**FINAL DRAINAGE REPORT
FOR
FOREST LAKES FILING 7
EL PASO COUNTY, COLORADO**

December 2021

Job no. 1175.70
PCD File # SF-21-49

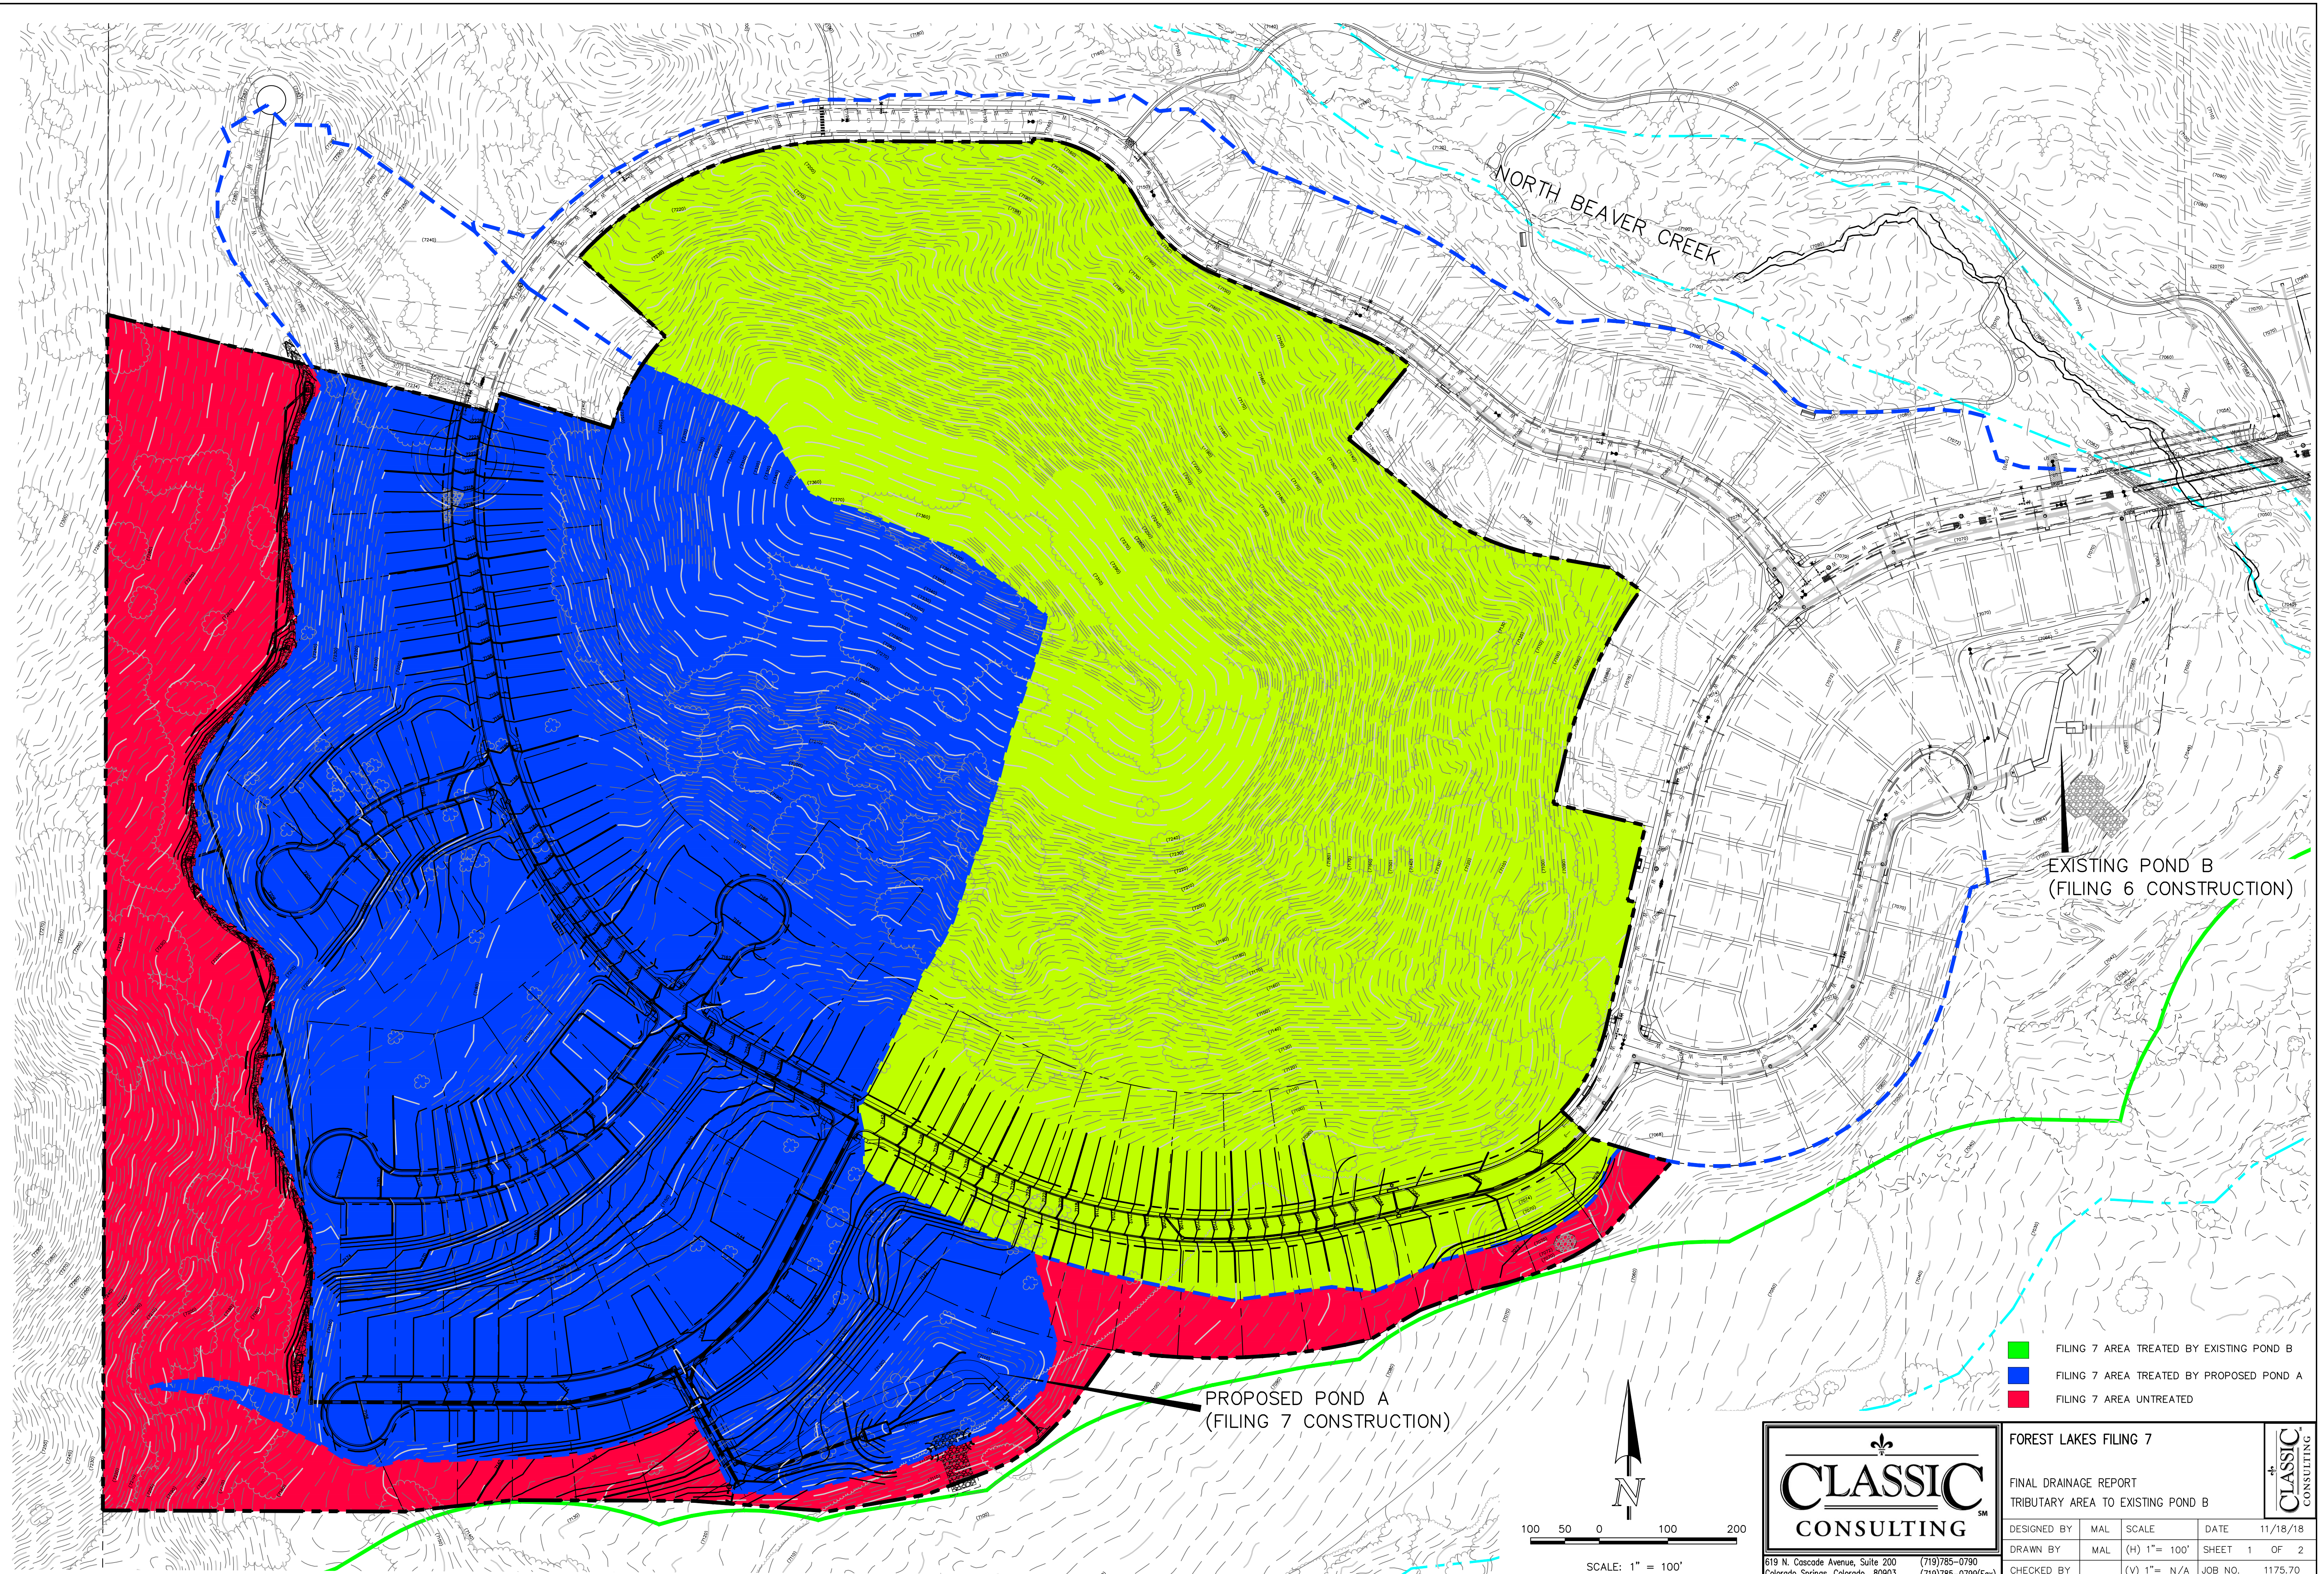
Unresolved-Please provide deviation request for velocities larger than 18 fps on new pipes.
